RECALL ACTION

Global Recall Action
Number: N685

Subject: Front Impact Sensor Torque Check	Publication No.: N685
	Model: Range Rover (LK)
	Model Year: 2022
	Date of Issue: 20 May 2022

Front Impact Sensor Torque Check

3.0L AJ20-D6 shown, 3.0L AJ20-P6 and 4.4L NC10 are similar.

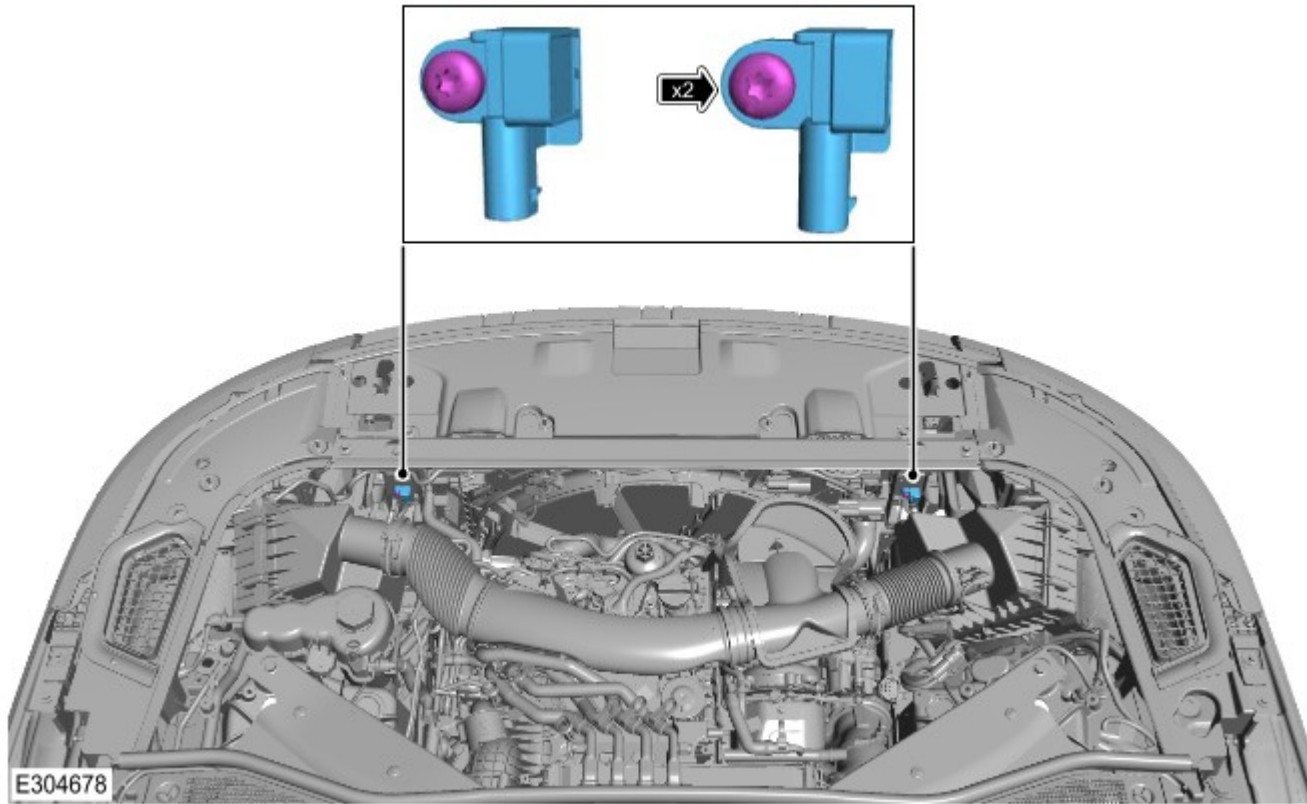
A concern has been identified on certain 2022 model year New Range Rover vehicles where the front crash sensor fixings may not have been installed to the specified level of torque. There is a risk that the front crash sensors may become loose resulting in incorrect operation of the active restraints system. This could lead to increased occupant injury or, in the case of inadvertent frontal airbag deployment, loss of vehicle control increasing the risk of a crash.

2. Locate and torque the 2 impact sensor bolts.

- Torque: **10 Nm**
